SOURIAU

Subject: Product Change Notification Change on UTO coupling gasket and receptacle housing

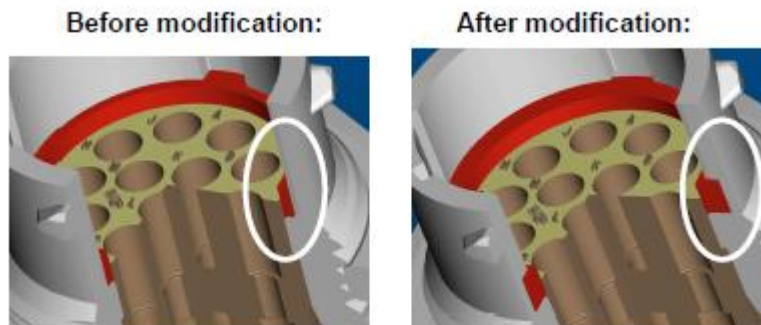
Description of Change: A groove is added in the UTO receptacle, and the design of the coupling gasket is changed

Reason for Change: Avoid the dislodging of the seal during shipment and to improve the dynamic sealing.
